Design Review Update

Parcel G

Reference: Parcel G Design Review

Cambridge Crossing

1. NORTH / SOUTH TRANSITION

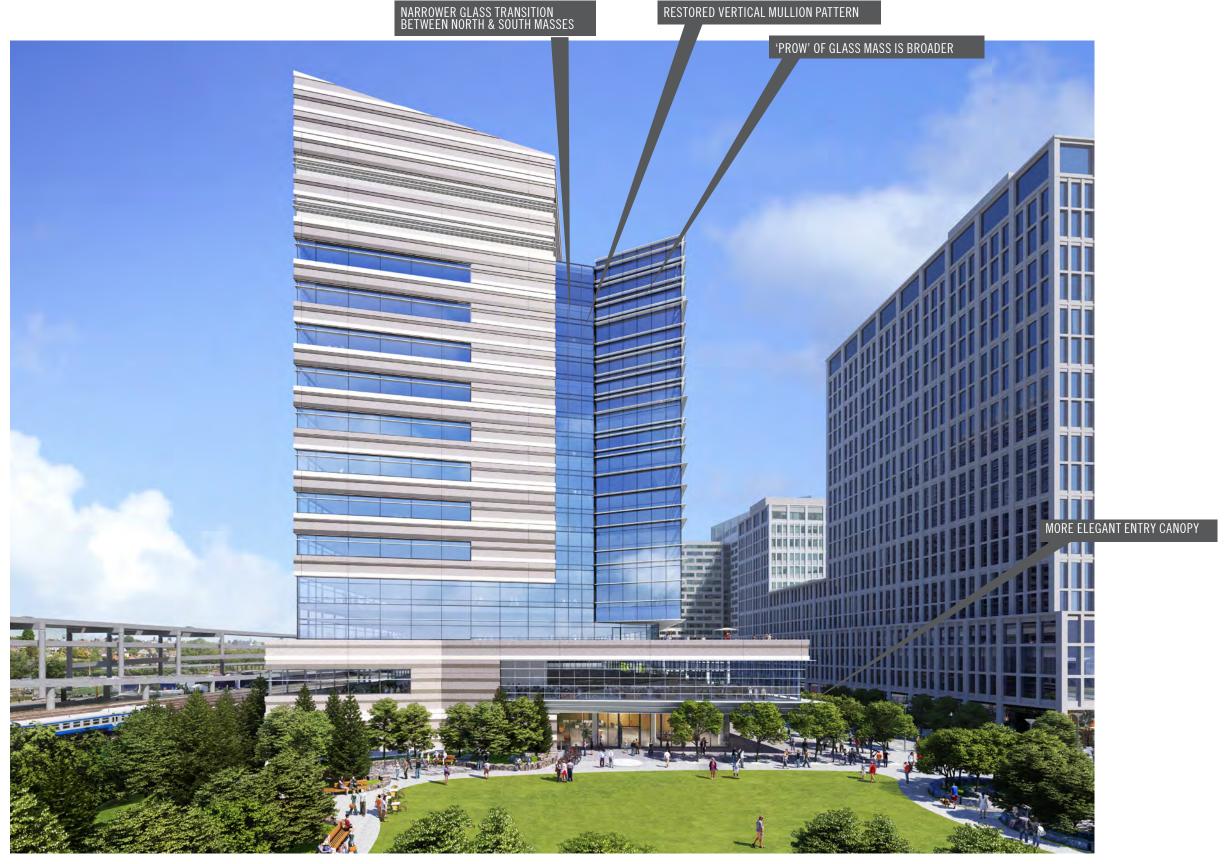
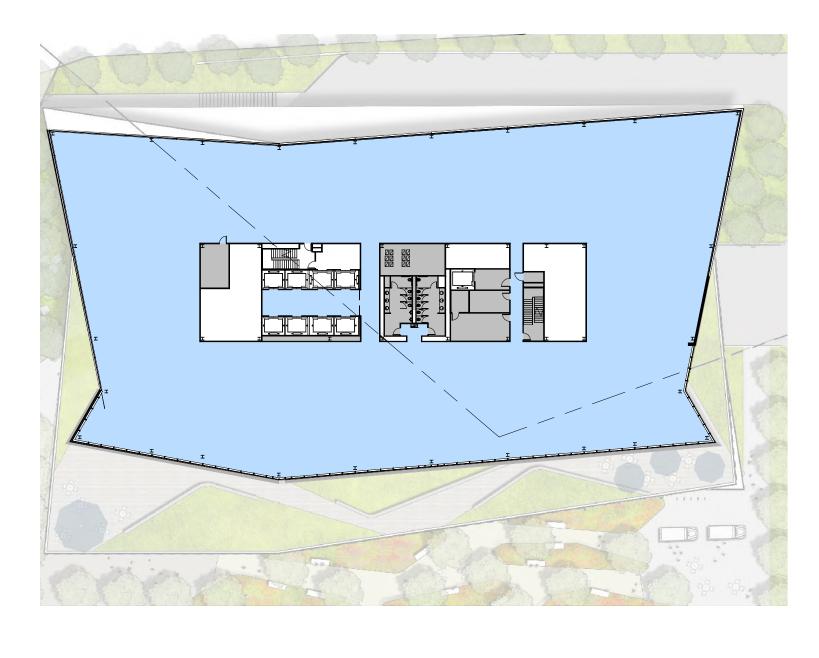
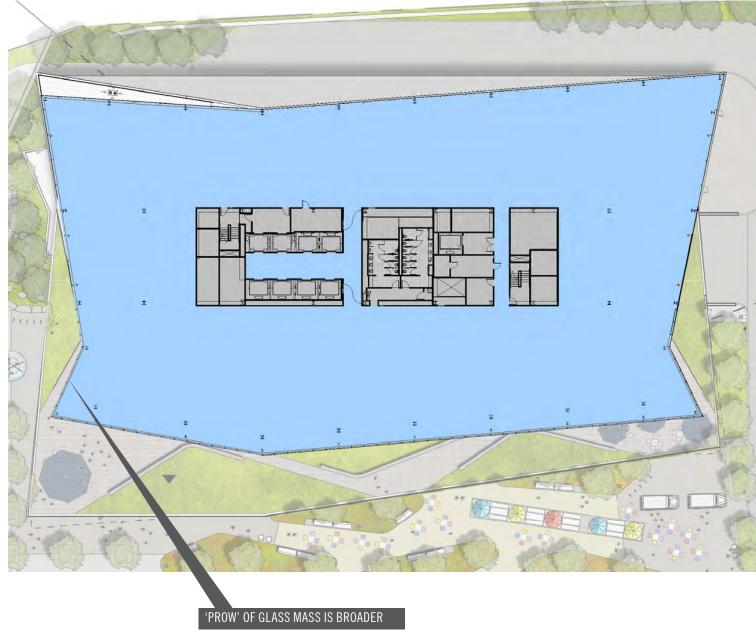
East and West Elevations		
9. On the east/west elevations, the glass zone between the two masses has been narrowed. This creates a more elegant proportion overall; however, the individual windows have become significantly wider and lack the elegance of verticality in the earlier scheme. They appear to be transitioning between the vertical windows in the southern portion and the horizontal windows in the northern portion in each elevation.	The mullion spacing within the glass zone has been revised to reflect the verticality of the 2017 approved design.	~

- <u>North/South Transition</u>: in response to your comments we have refined the treatment of the glass between the northern precast and southern glass building masses, including reestablishing the vertical proportion of the 2017 approved design.
- Podium Façade: in response to your comments we have refined the design of the two-story plinth façade, maintaining the two-story expression. We have redesigned the treatment of the fire command center façade next to the building entry by adding ground floor glass with wood screening.
- <u>Sunshades</u>: in response to your comments on the southern glass building mass we have returned to sunshades that extend 24" and 18" per the approved 2017 design.
- <u>Northern Façade</u>: in response to your comments we returned to the façade patterning and mechanical louver detailing of the approved 2017 design.

2018 PROPOSED DESIGN

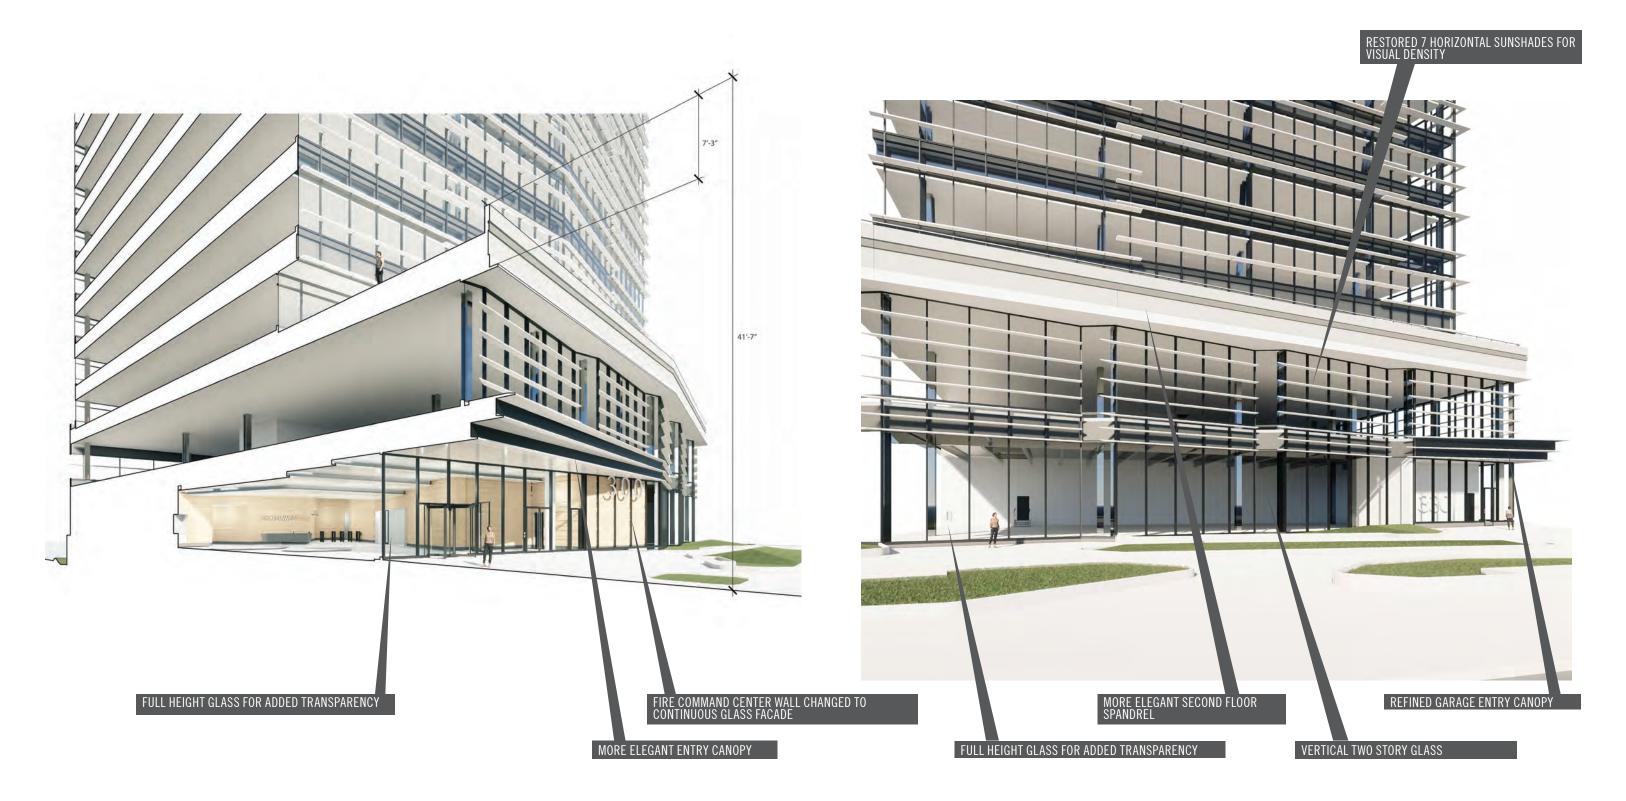
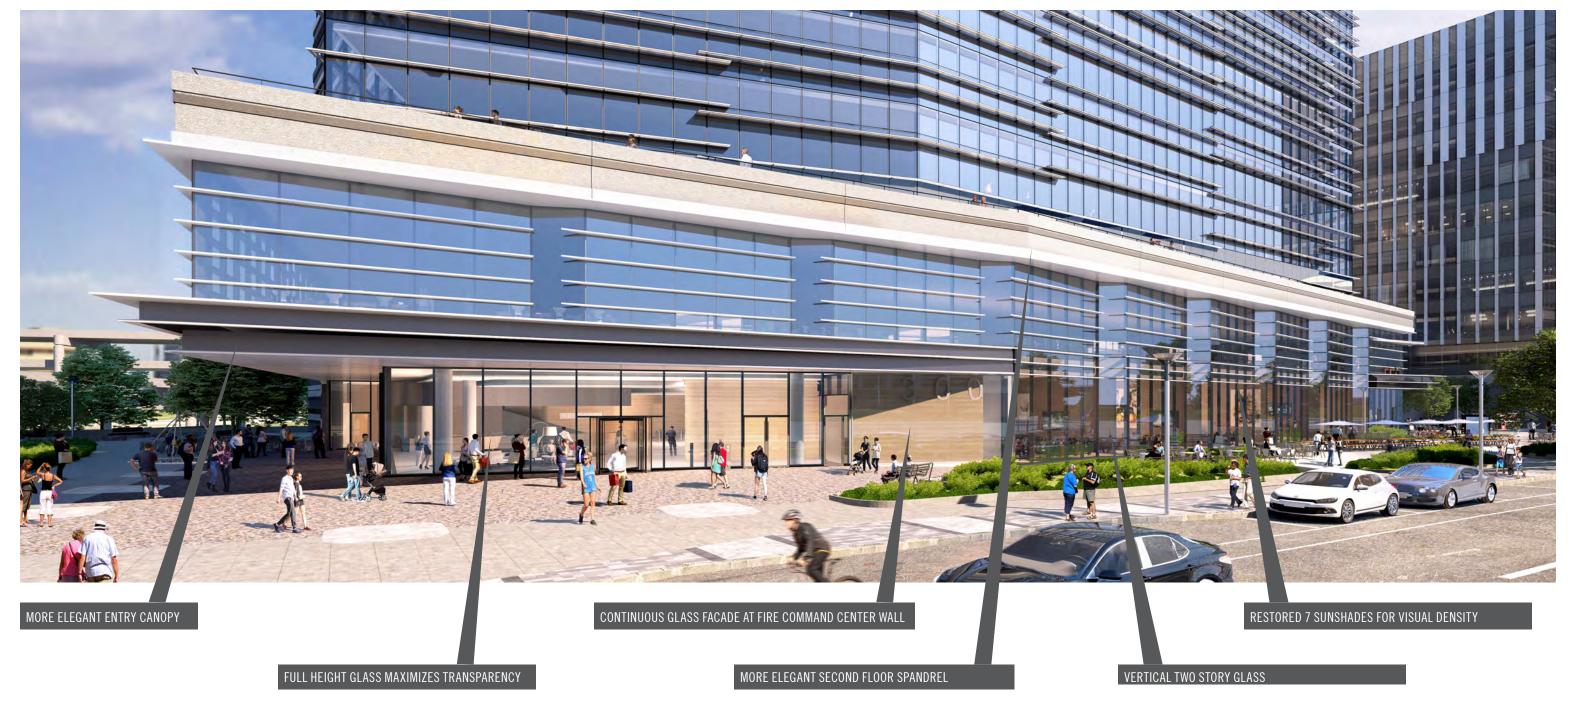
15. The depth of horizontal sunshades has reduced from 24" and 18" in the approved design to 12" in the revisions. Additionally, the sunshades were previously horizontal louvers, rather than an extruded horizontal fin. While refinements are expected as design development occurs, such a change in scale, particularly on a large building, may have a negative impact on the façade's visual relief and interest.	The sunshade depths have been changed back to 18"and 24" and made into horizontal louvers, consistent with the 2017 approved design.	~
Hearing on November 13, 2018

MORE ELEGANT ENTRY CANOPY

RESTORED 7 HORIZONTAL SUNSHADES FOR VISUAL DENSITY

FULL HEIGHT GLASS FOR ADDED TRANSPARENCY
